SITE PLAN REVIEW AND APPEARANCE BOARD STAFF REPORT

| SITE PLAN REVIEW AND APPEARANCE BOARD | | | |
|---|---|--|--|
| Meeting: January 9, 2019 | File No.: 2018-177 Class I | Application Type: Class I Site Plan Modification | |
| Applicant Delray Awning Location: 411 E. Atlantic Avenue PCN: 12-43-46-09-11-001-0010 Property Size: 0.3 Acres FLUM: CC (Commercial Core) Zoning: CBD (Central Business District Adjacent Zoning: | , Office and Restaurant oproval of a Class I Site Pla install a new fabric awning | | |

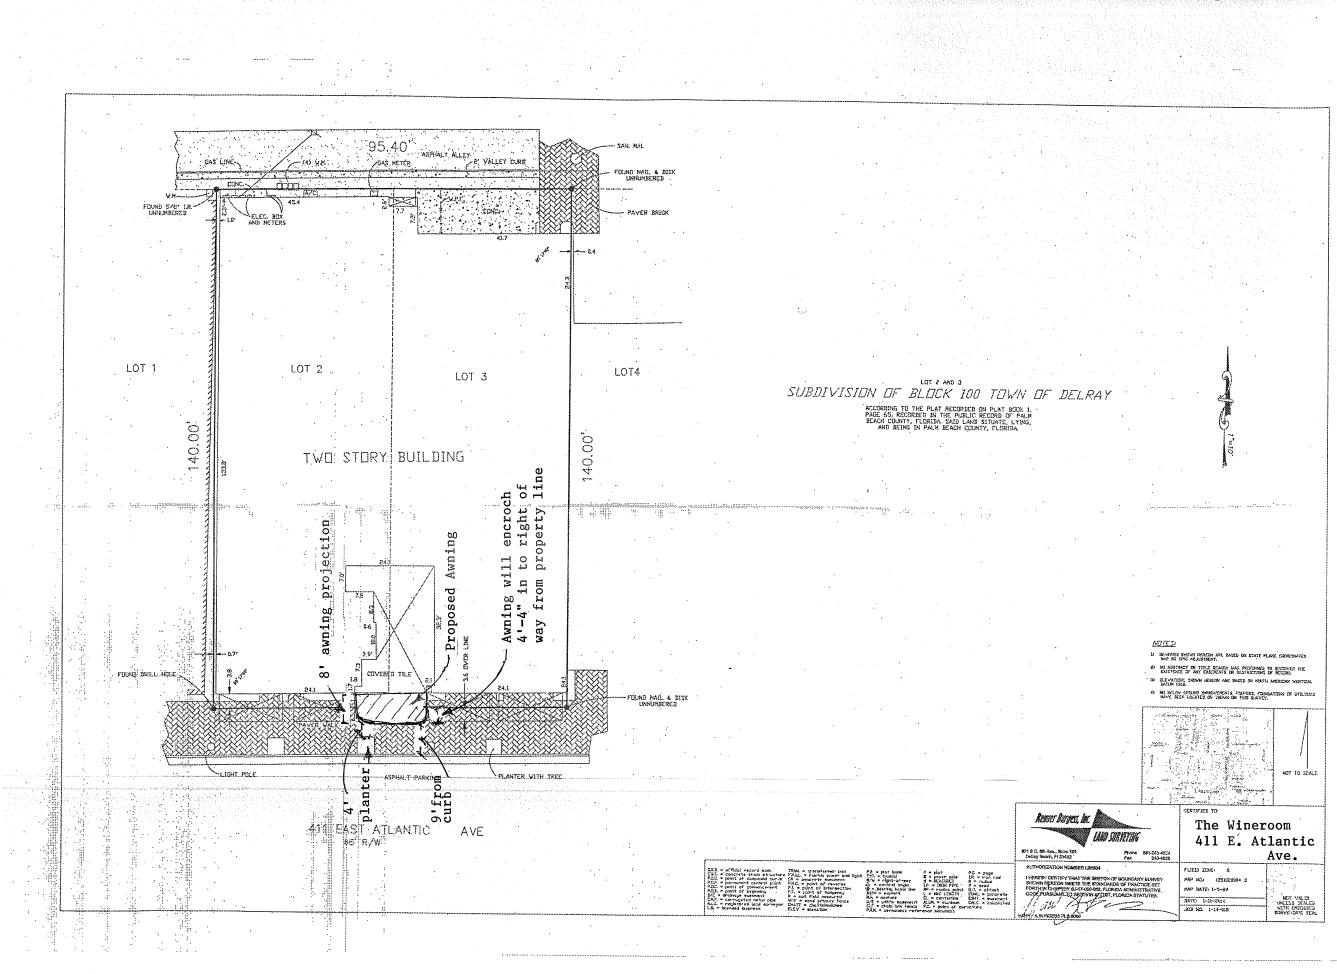
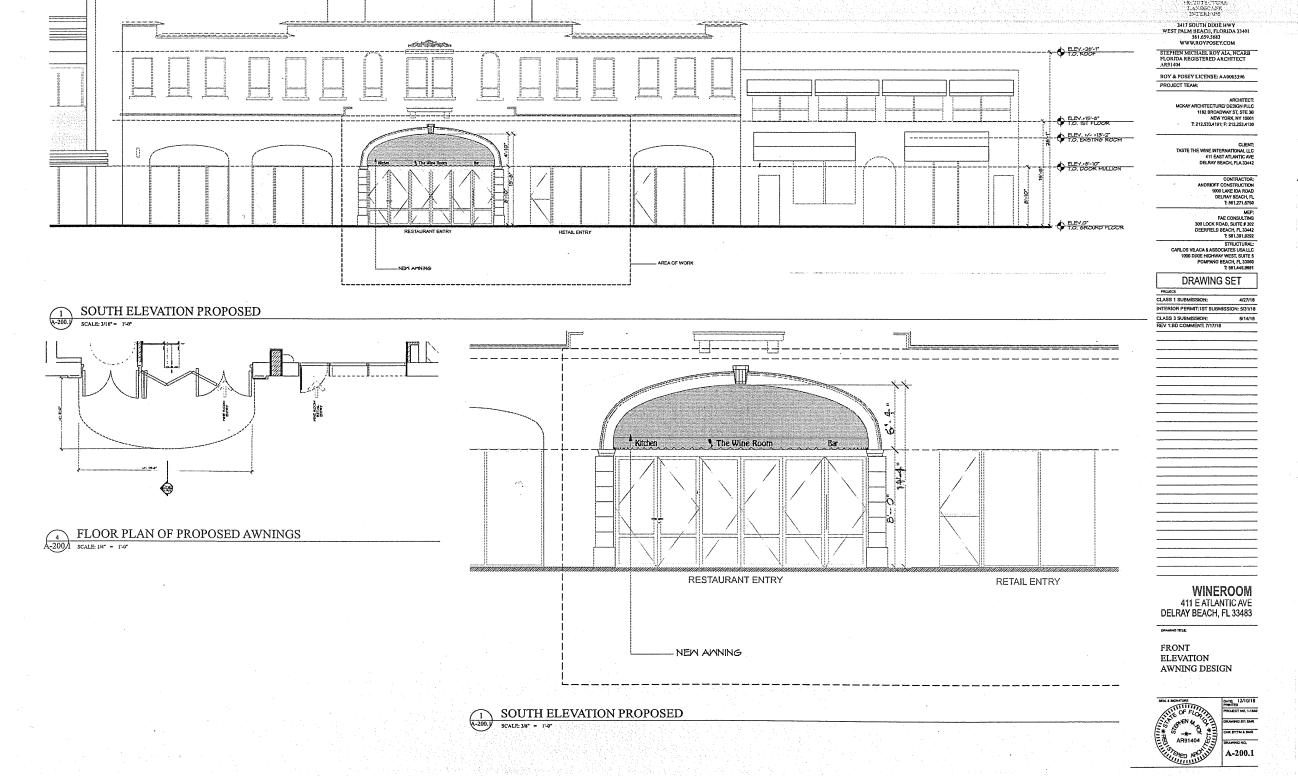
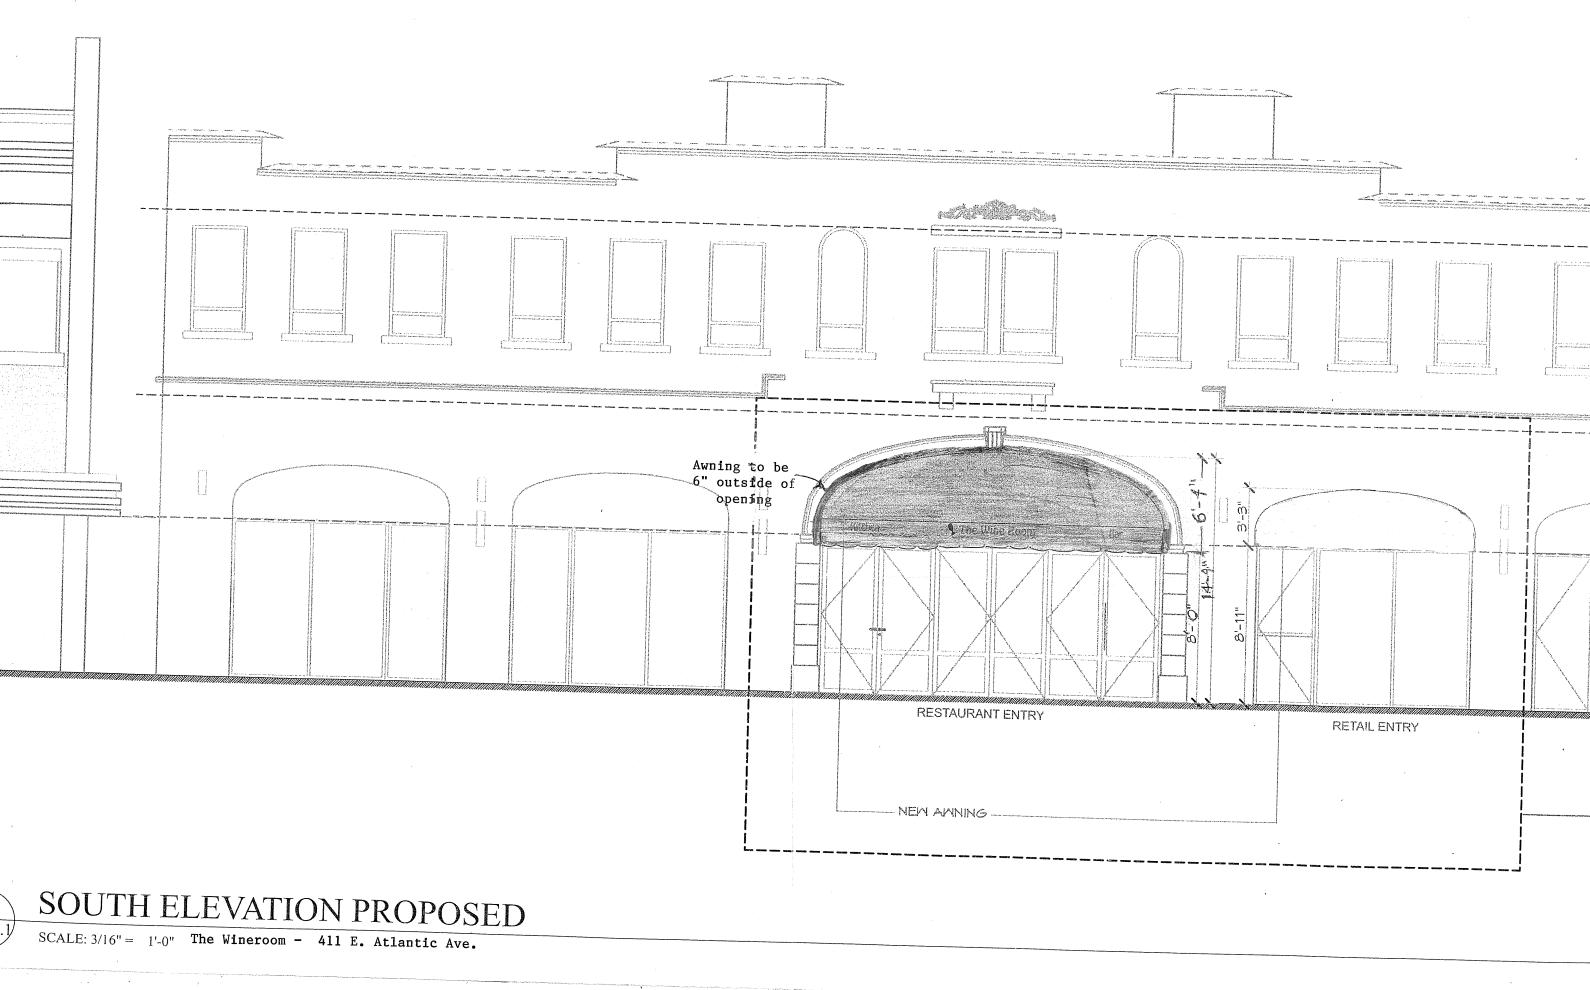
The proposed architectural elevation change includes the construction of one new 20' by 8' dome slope styled fabric awning located above the main entrance to the restaurant on the front (south) elevation of the property. The proposed new fabric awning is to be in the Sunbrella Black Cherry color style. The awning is to be mounted at a height of 8'11"'. The masonry archway was removed and is required to be reinstalled before the awning is mounted to the main entrance. The proposed awning will encroach into the public right-of-way. Pursuant to LDR Section 4.3.4(H)(4)(o) canopies, marquees and covered walkways may extend within front and side setback areas in commercial zone districts through the approval of Canopy Hold Harmless Agreement with the City per LDR Section 6.3.4.

The proposed architectural elevation changes will not adversely affect the surrounding area, will not materially depreciate the neighboring areas, and the proposed changes are consistent with the selected architectural style. Based on the above, positive findings can be made with respect to LDR Section 4.6.18(E).

- That a hold harmless agreement be approved and recorded for the canopy prior to issuance of a building permit.
- That the original masonry archway be reinstalled prior to the awning installation and issuance of the canopy permit.
